| Project Title: | Hydrogen Energy Center Application for Certification Amendment |
| Document Title: | Project Refinements |

Re: Hydrogen Energy California Project (08-AFC-8A): Project Refinements

Amended Application for Certification for HYDROGEN ENERGY CALIFORNIA (08-AFC-8A) Kern County, California

REVISED FIGURE 1-4

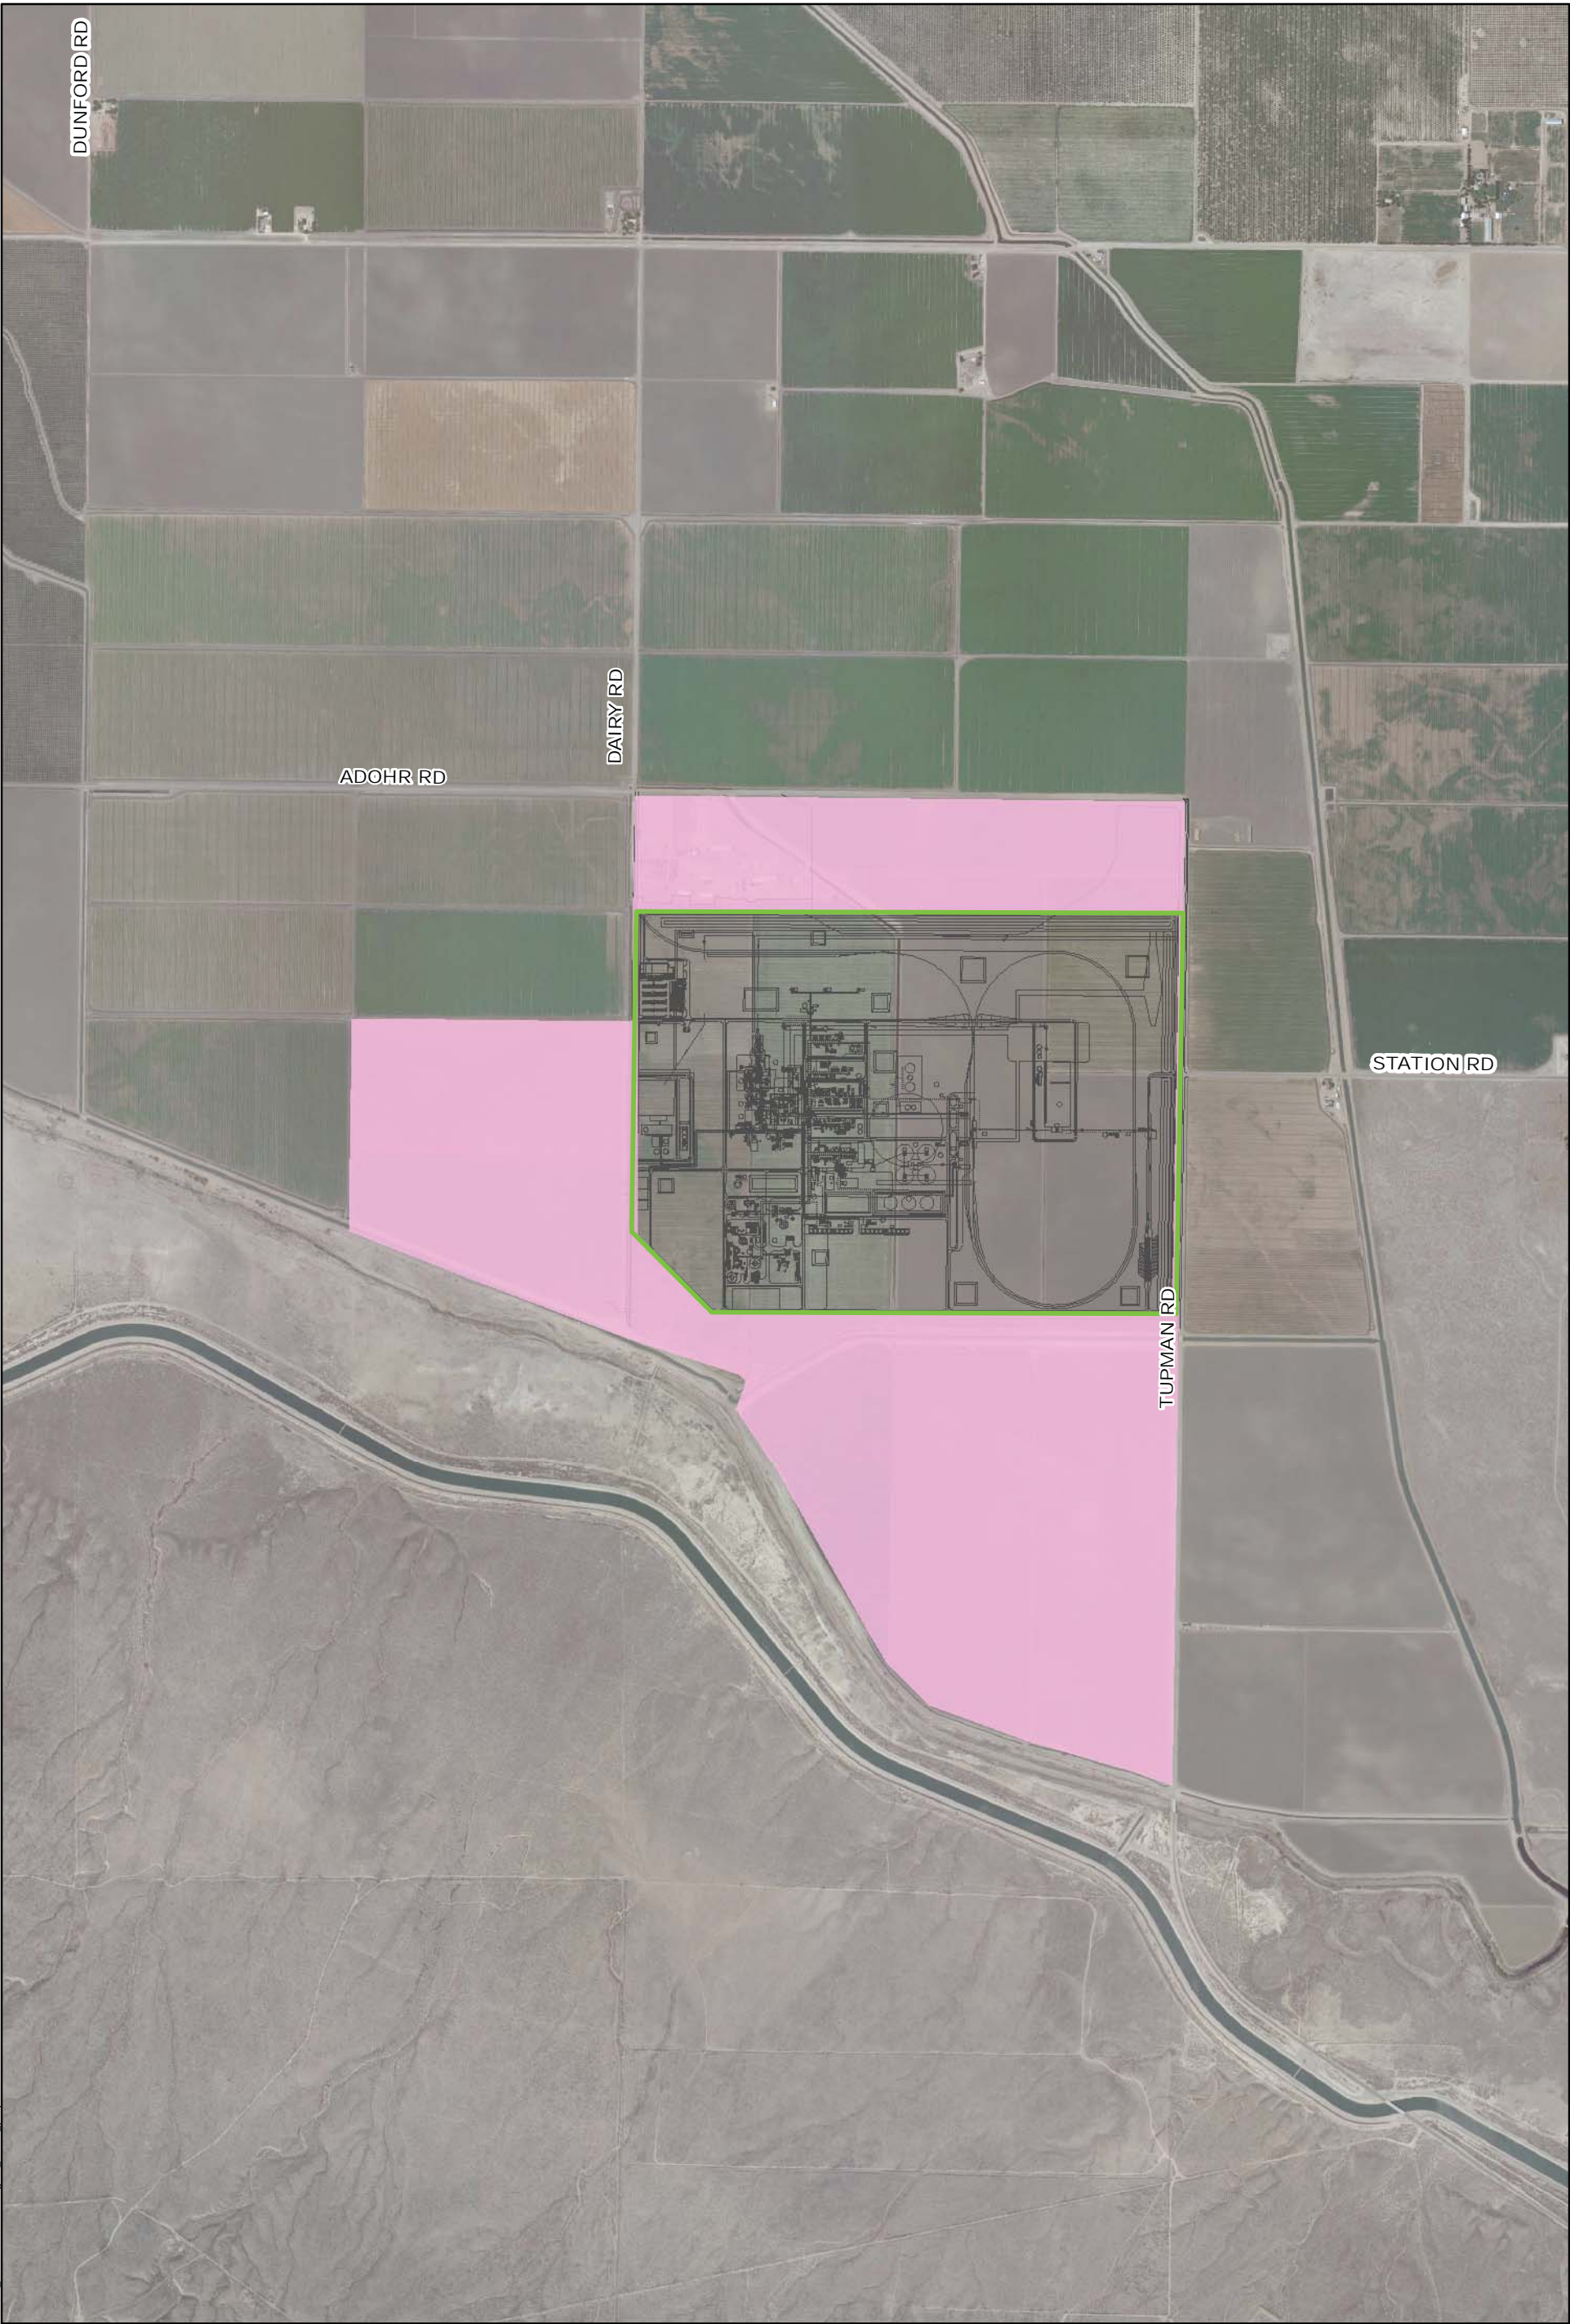
The project refinements described below do not substantially alter the nature of the Project; they are the result of further detailed project design and regulatory feedback received. An updated computer rendering of the Project is shown on Revised Figure 1-4, Project Site – Project Rendering.

REVISED FIGURE 2-4

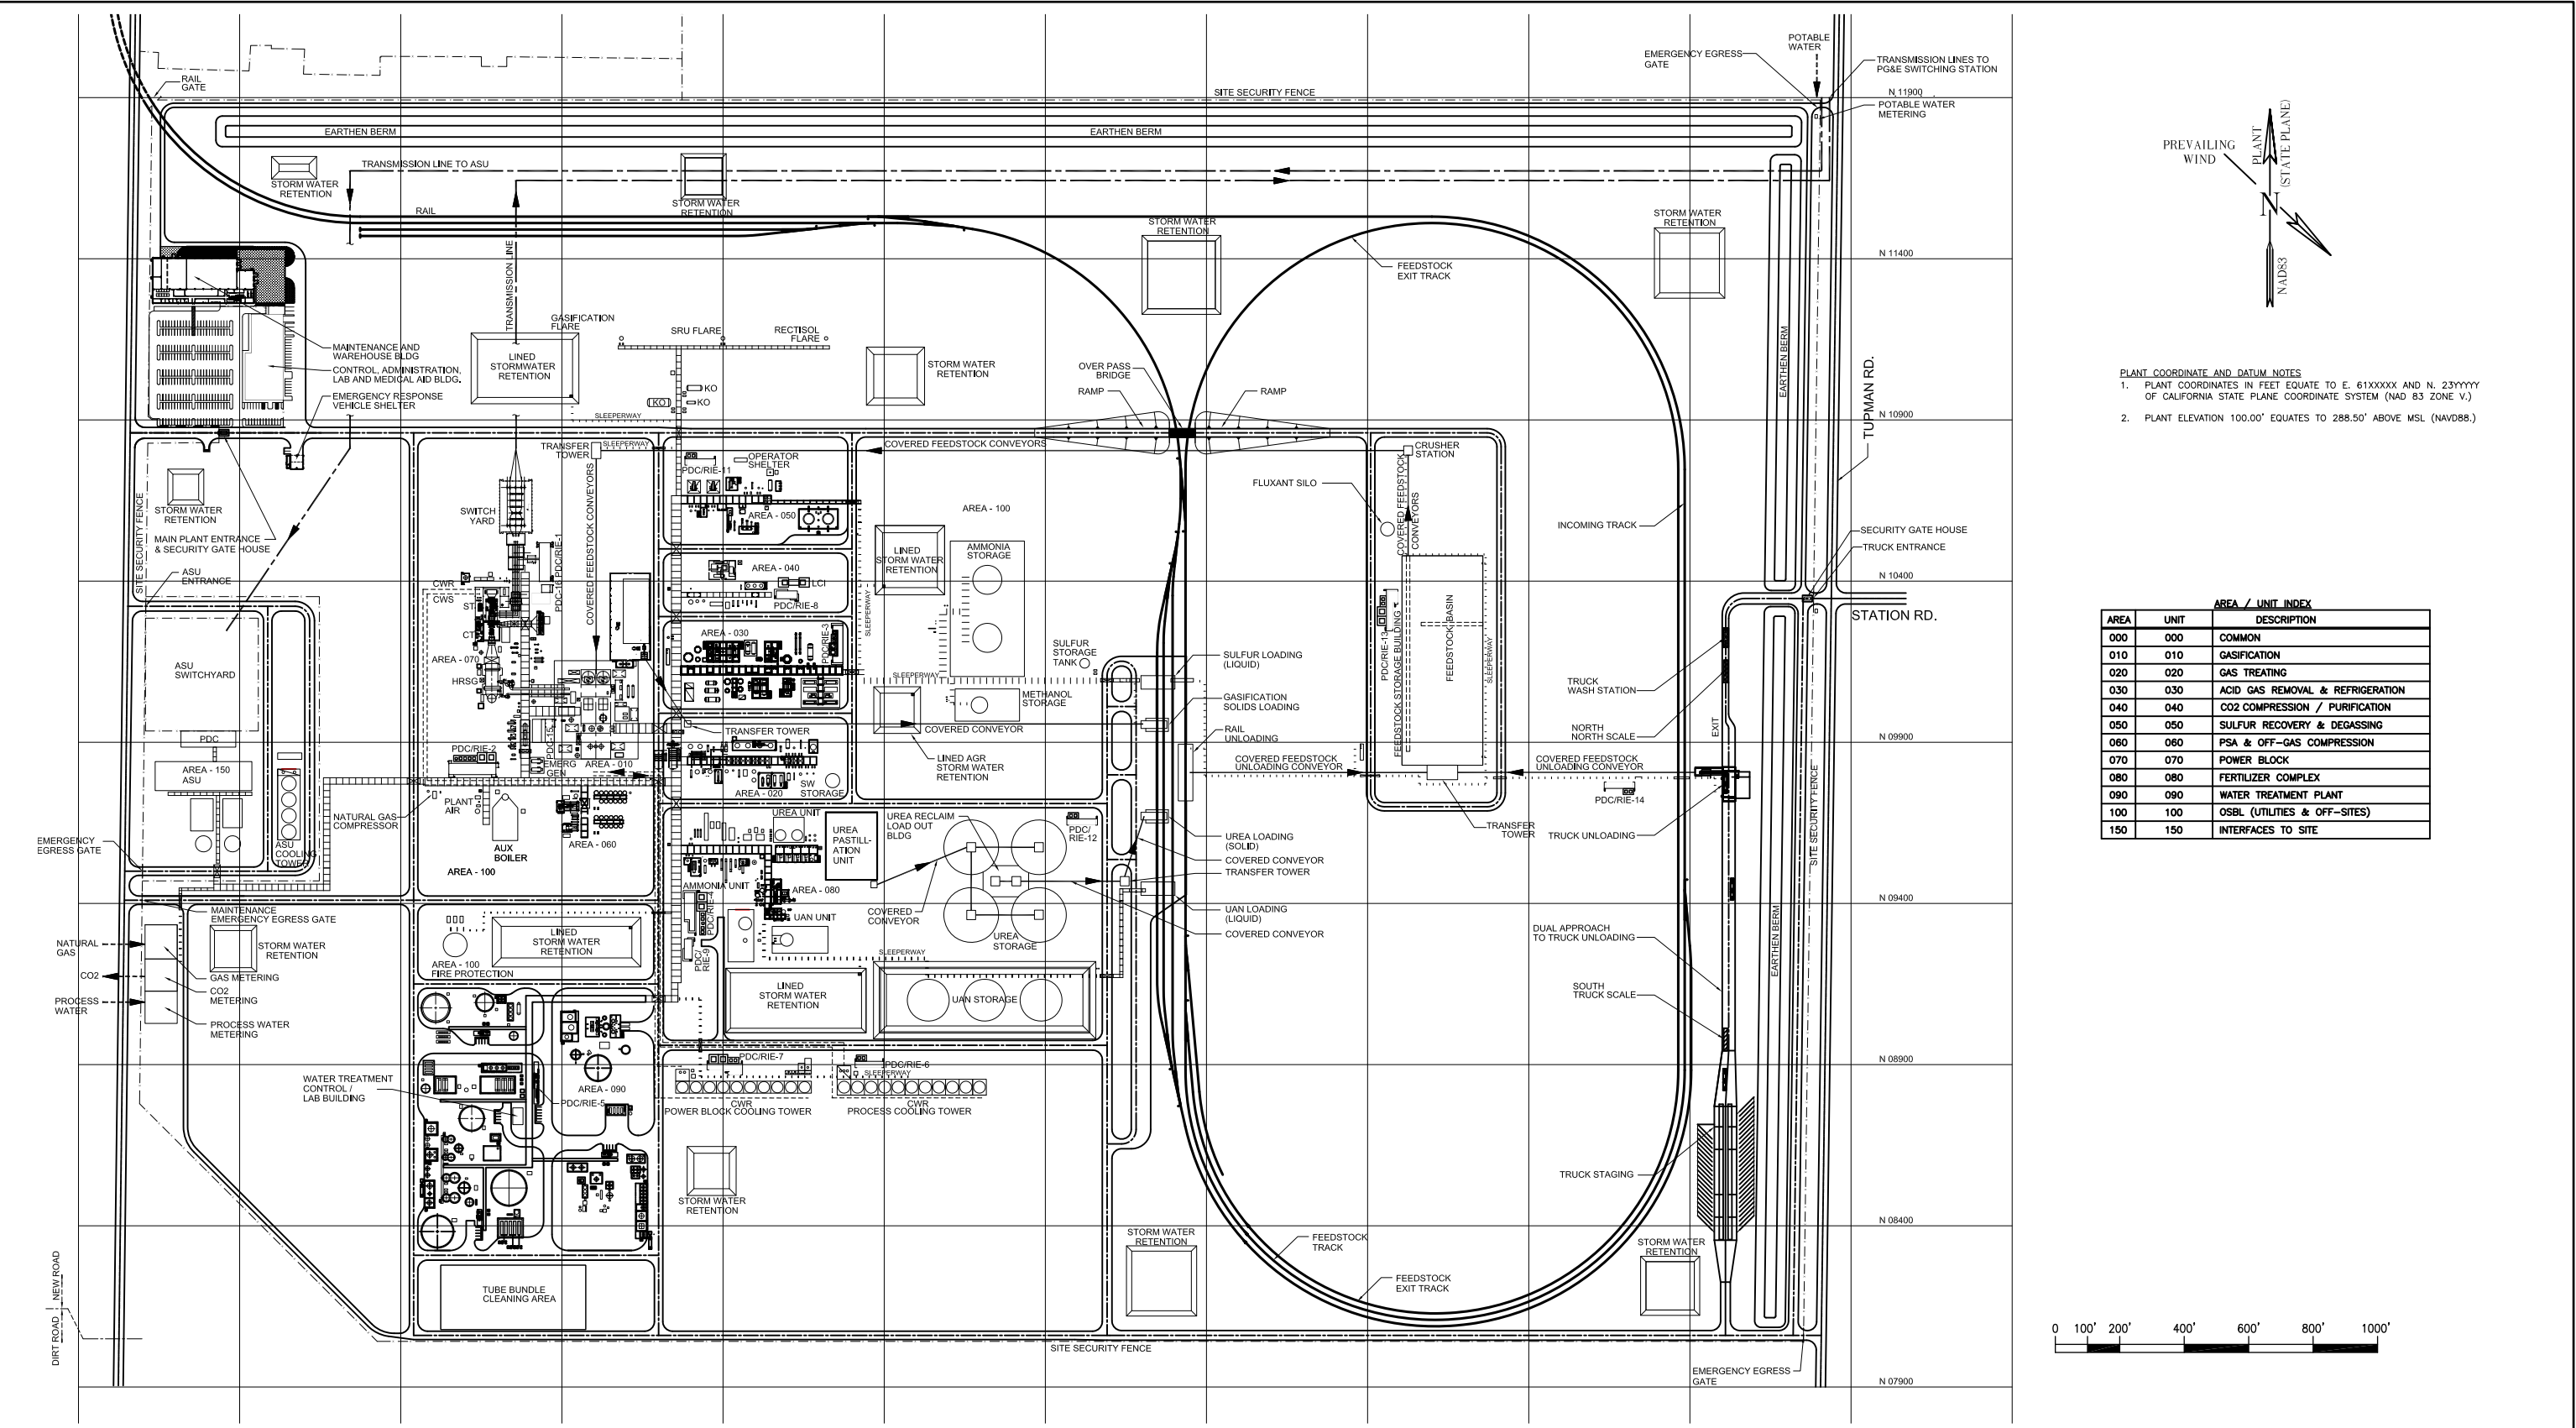
Major components located on the Project Site will remain essentially the same as described in the Amended AFC. The locations of some features have been adjusted, including the heat recovery steam generator (HRSG), feedstock dryer, cooling towers, flares, CO₂ vent, Manufacturing Complex features, material handling features, and emergency engines. Several buildings and tanks were moved slightly or have revised dimensions. A few stacks have different heights and parameters. These components are shown on Revised Figure 2-5, Preliminary Plot Plan, Revised Figure 2-6, Project Elevations, and Revised Figure 2-47 Preliminary Emission Sources Plot Plan.

The coordinates of the fence around the Controlled Area along Tupman, Adohr, and Dairy roads were moved slightly in towards the center of the Project Site to ensure adequate roadway easement. Additional retention basins have been added to the site plan; the overall conceptual designs of the retention basins have not changed. All retention basins are still within the 453-acre Project Site.
